**ADDENDUM NO. 1 TO PROJECT NO. Q1574**

**CONSTRUCTION WORK  
PROVIDE SECURITY & UTILITIES FOR CONTAINERIZED OFFICES  
ARMY AVIATION SUPPORT FACILITY  
330 OLD NISKAYUNA ROAD  
LATHAM, NY**

July 12, 2013

DWG NO:  
**E-101A**

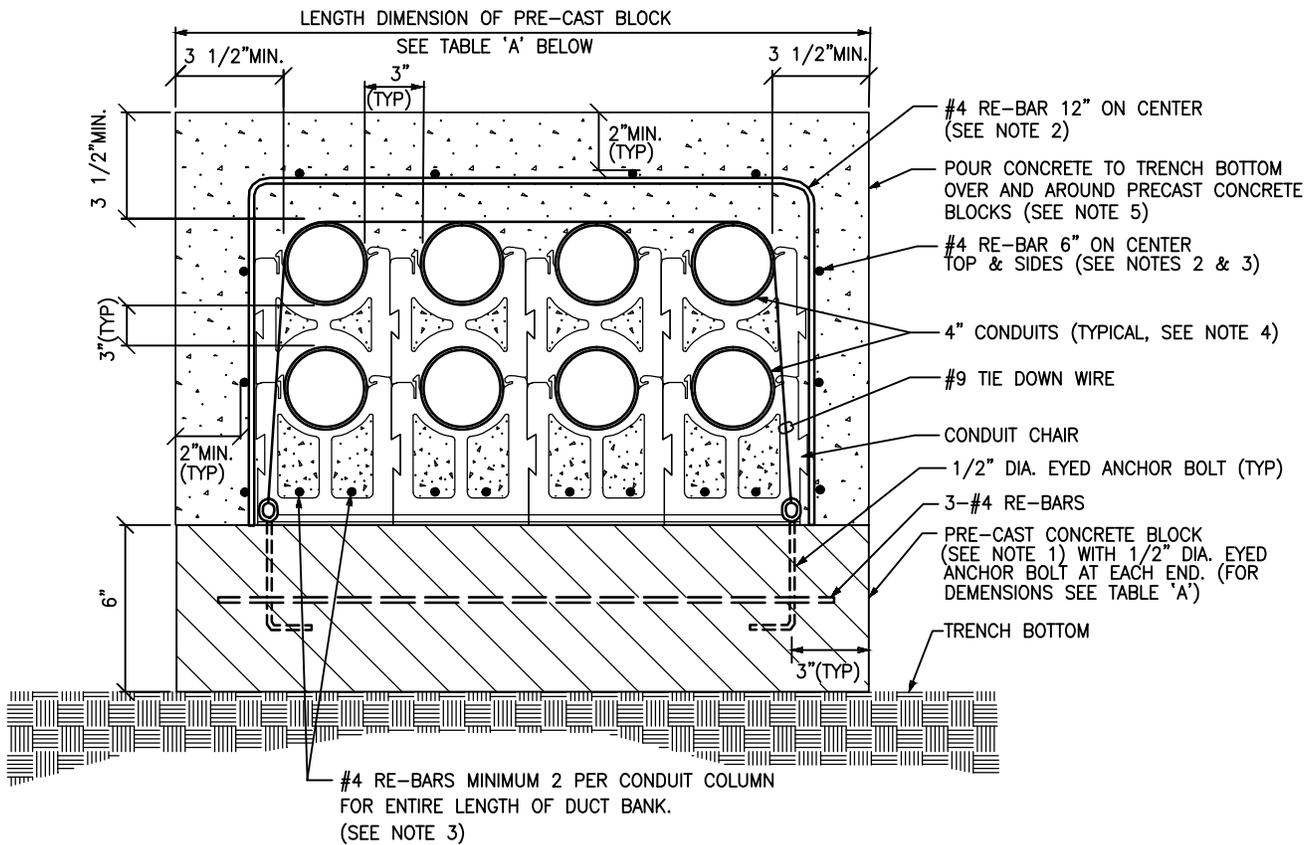
“GENERAL NOTES:  
A. All underground conduit shall be concrete encased.”.
6. Revised Drawings:
  - a. Drawing No. C-101, noted “REVISED DRAWING” is attached to this Addendum and supersedes the drawing bound in the Project Manual.
  - b. Drawing No. C-102, noted “REVISED DRAWING” is attached to this Addendum and supersedes the drawing bound in the Project Manual.
7. Addendum Drawing:
  - a. Drawing No. E-101A, noted “ADDENDUM DRAWING 7/12/2013” accompanies this Addendum and forms part of the Contract Documents.
